HAMILTON CITY COUNCIL SUBMISSION ON:

Land Transport Rule: Traffic Control Devices (Kura/School Signs) Amendment 2021 (Proposed Rule)

Waka Kotahi NZ Transport Agency

17 December 2021

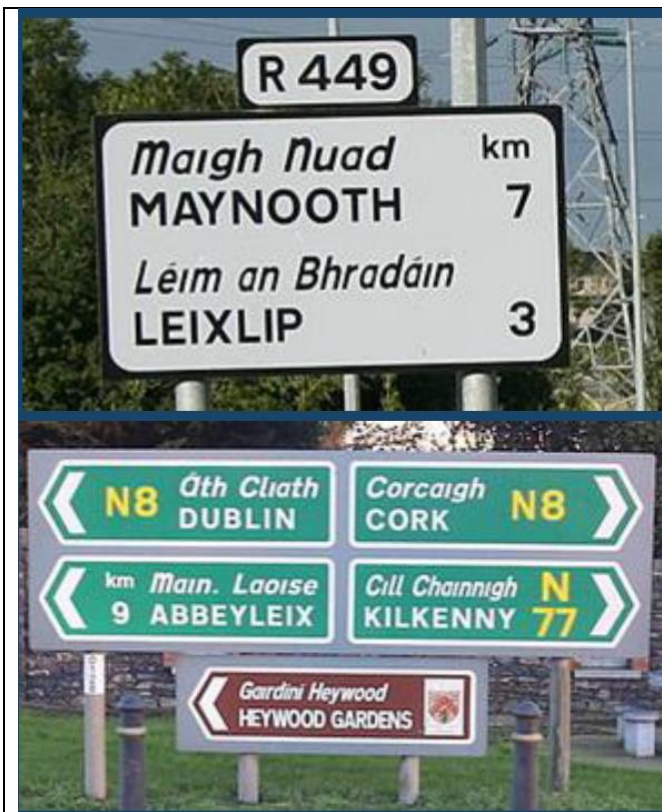
9. **Do you have any feedback on the proposed design of the new Kura School traffic sign?**
10. Hamilton City Council agree with the idea of including Te Reo on this signage but recommend that it be in Title Case (rather than CAPITALS) as is illustrated in the examples within the consultation document (and below). We believe this will better facilitate future expansion of Te Reo across other road signs in a consistent manner.

Hamilton City Council agrees with the idea of including Te Reo on this signage but recommend that it be in the Title Case (rather than CAPITALS) as is illustrated in the examples within the consultation document (and to the left). We believe this will better facilitate future expansion of Te Reo across other road signs in a consistent manner.
